31 May 2019
Our Ref: 18044 Rev E

Re: Anglicare Bulli Village, Sandon Point

I respond to the traffic matters summarised in your correspondence dated 27 March 2019 (Appendix A).

SP 6

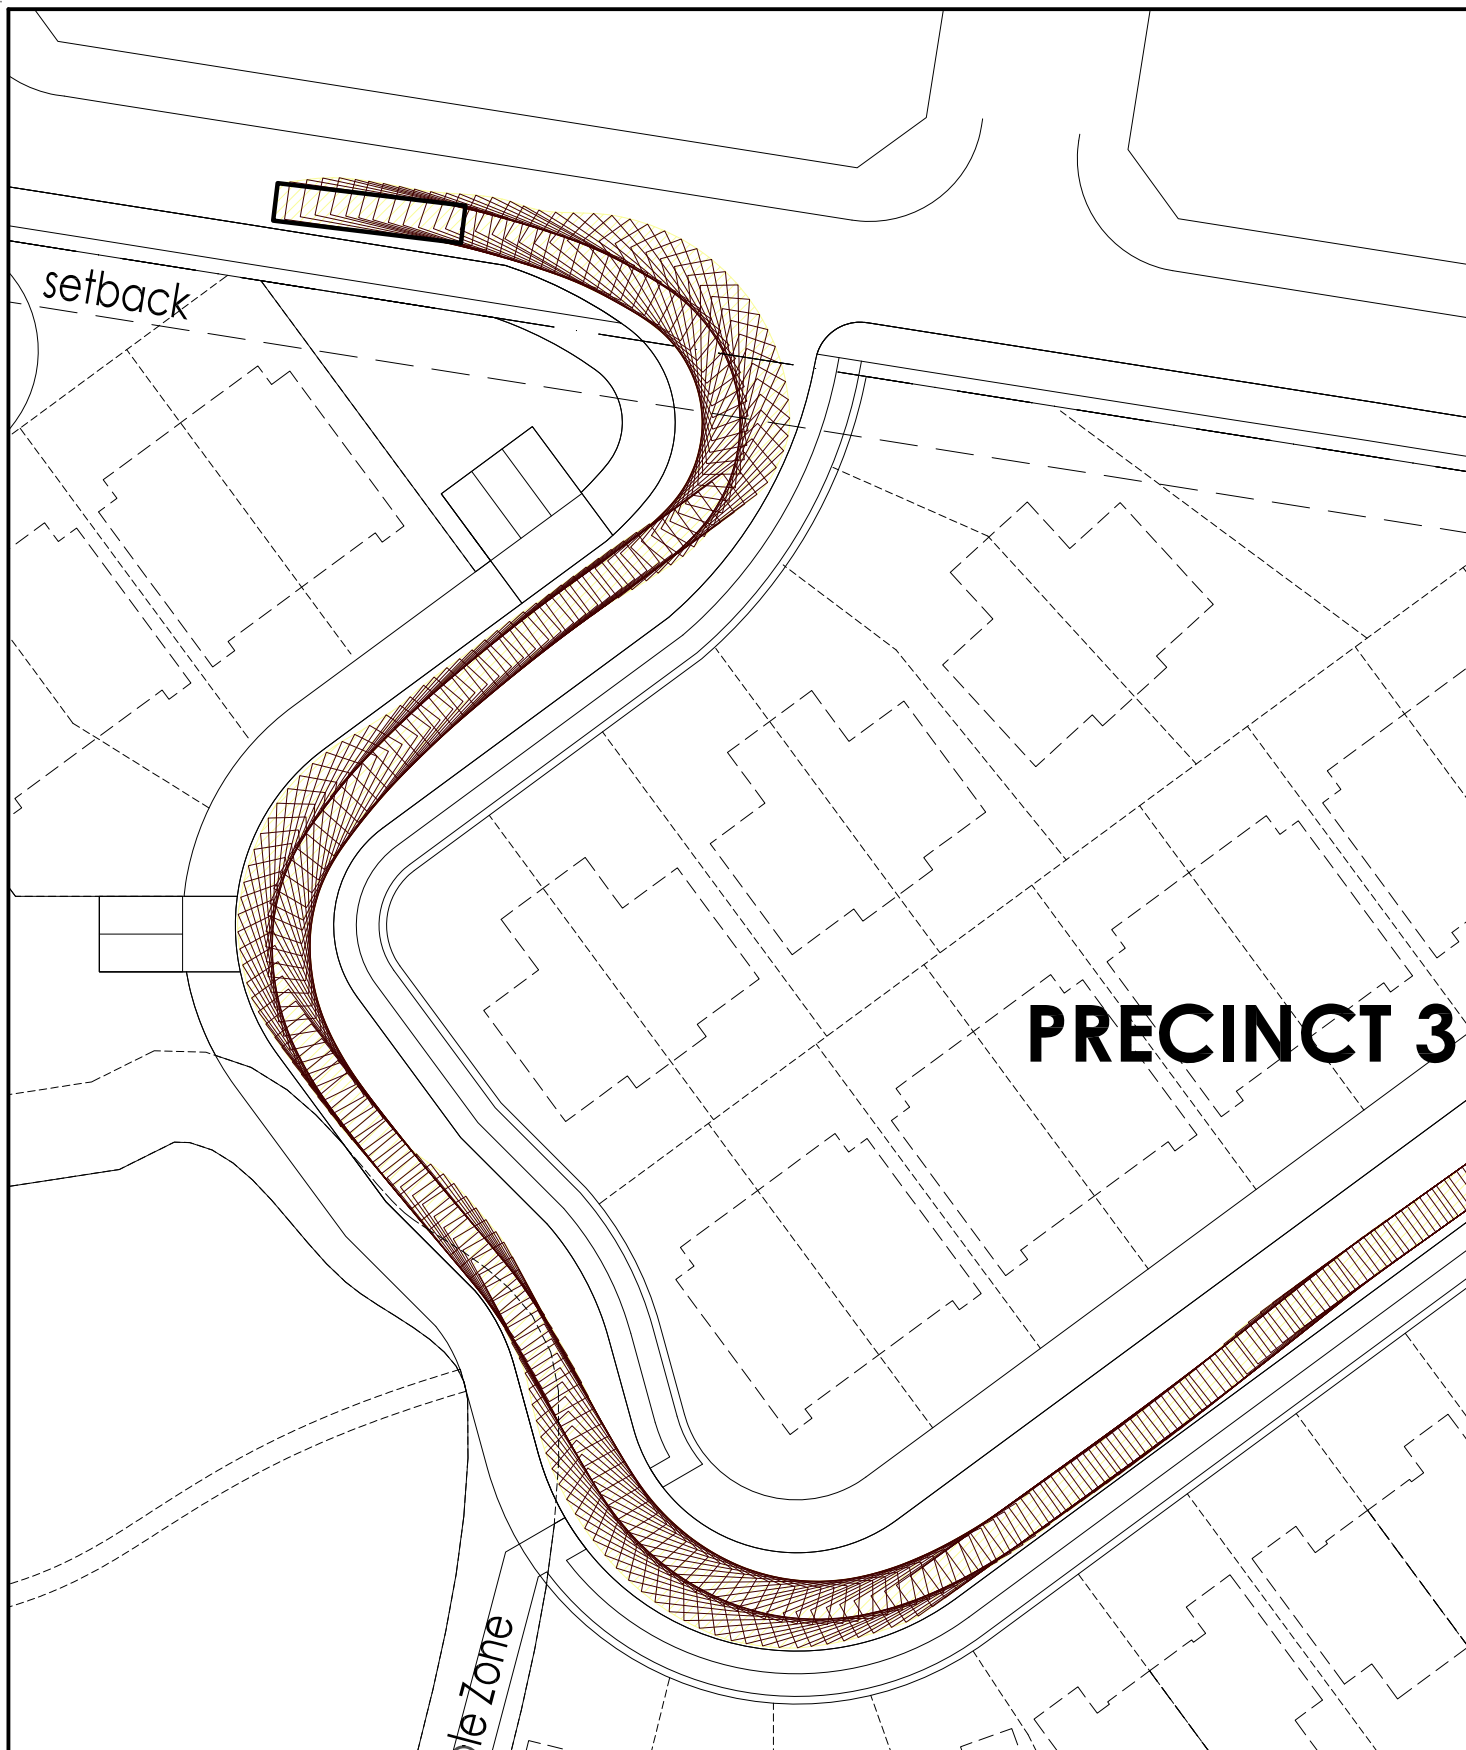
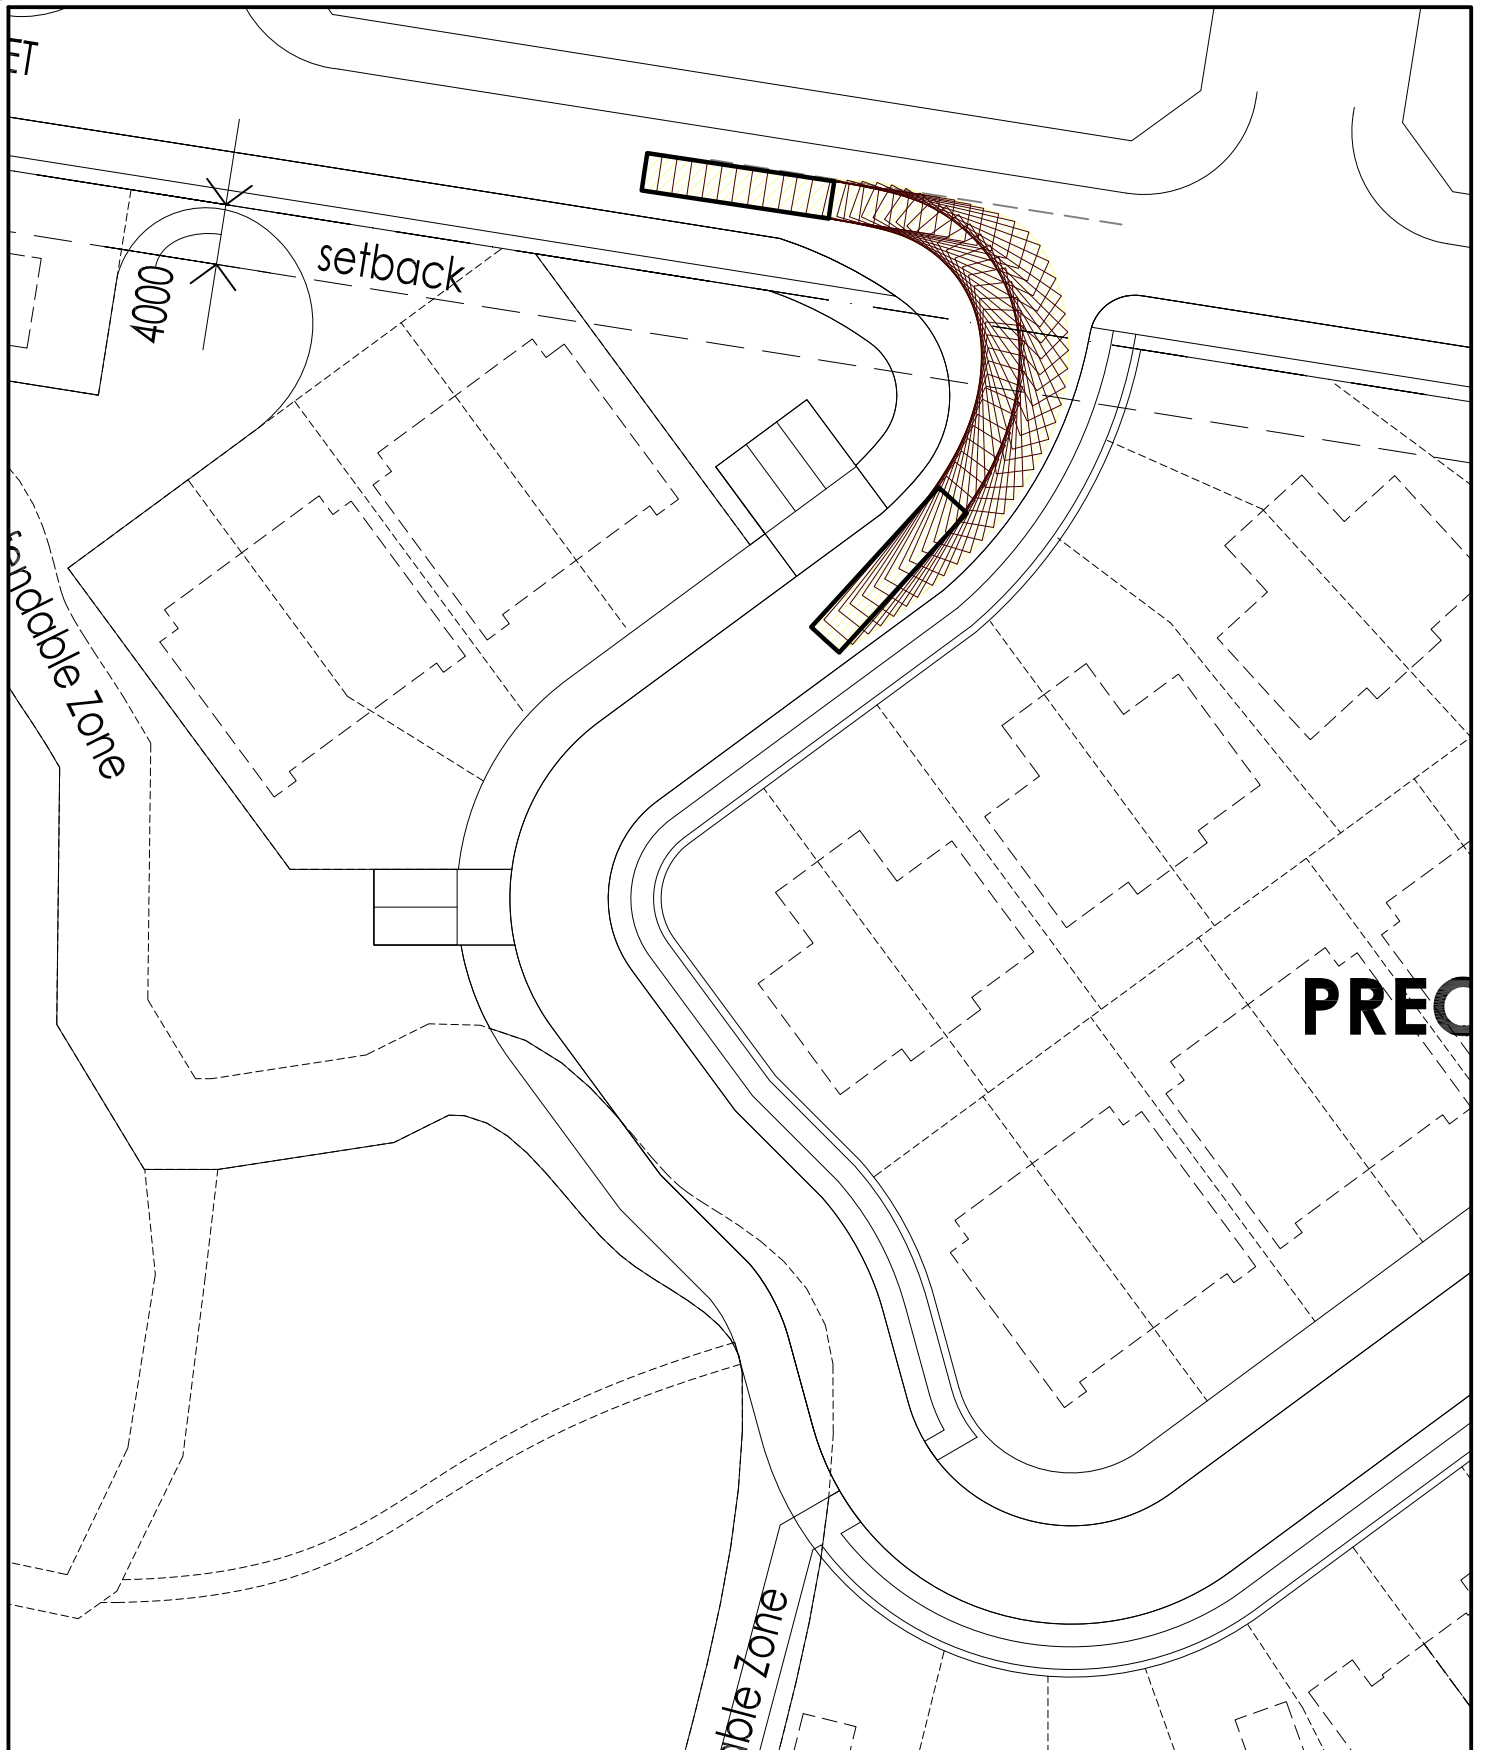
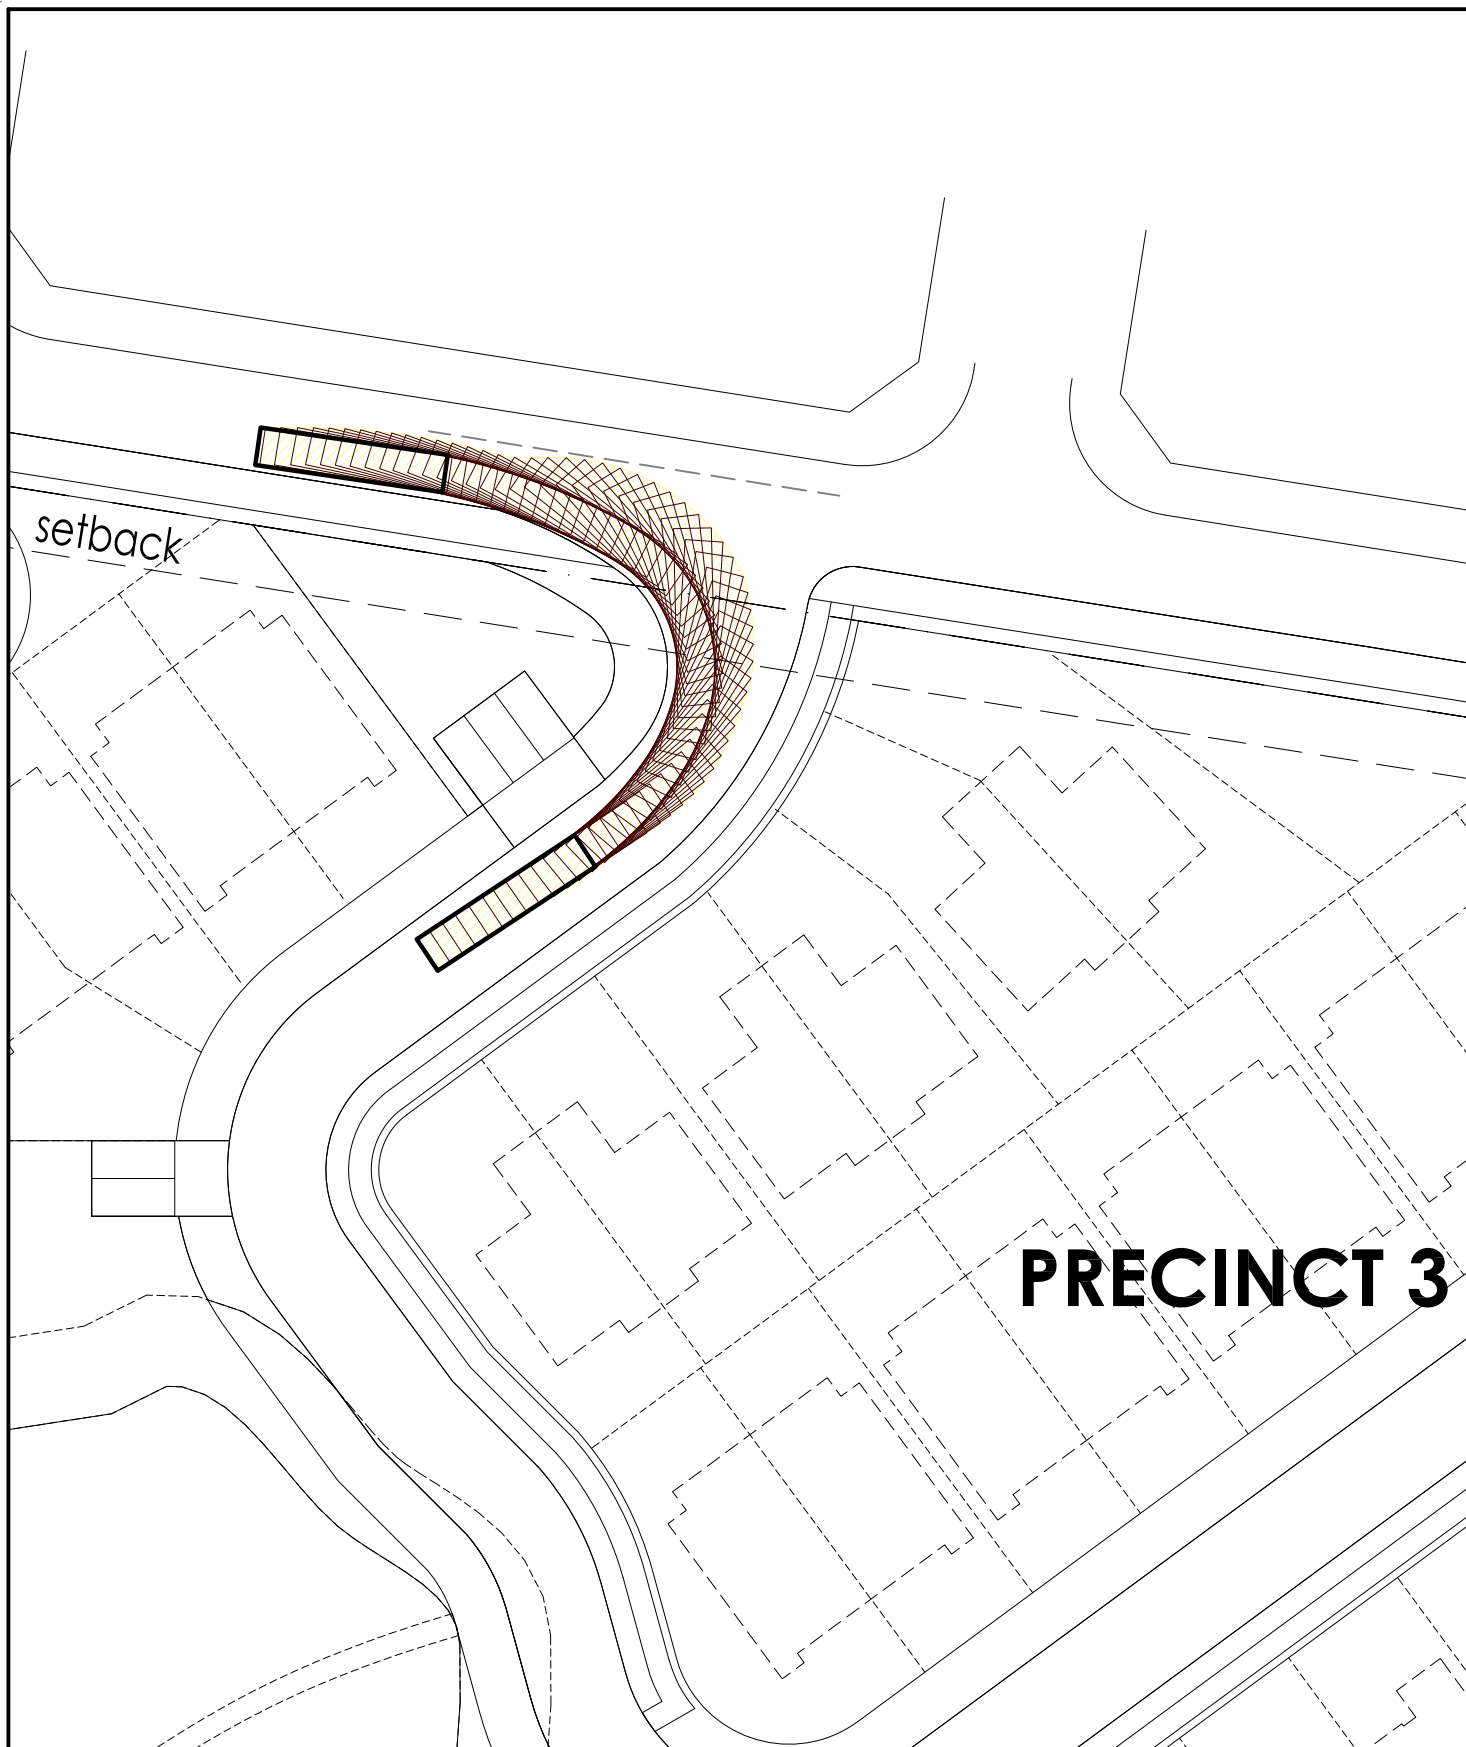
Concern is raised over the width of the proposed internal road network and the ability to carry out waste collection.

- The proposed garage widths will have regard for the AS2890.1 design requirements i.e. 3m minimum for a single vehicle garage and 6m for a double garage.
- Appropriate swept path assessment has been undertaken using 12.5m HRV at the entire estate's road network. Details of the assessment which demonstrate ability for the HRV (i.e. longer than Council's refuse vehicle of 10.2m) to negotiate the circulation roadways are provided in Appendix B. It is noted that the cul-de-sac is bounded by trafficable landscape features to accommodate the occasional truck manoeuvres.
- The parking requirements for visitors and residents for Seniors Living developments are subject to the SEPP criteria, not the DCP. As such, the SEPP requirement in this regard of 168 spaces will be accommodated for in the development. The proposed 51 residential dwellings will generate a parking

- The ILU cul-de-sac can accommodate the turning manoeuvre of a 12.5m HRV with no undue difficulty. Details of this provision are demonstrated on the swept path diagram in Appendix B.
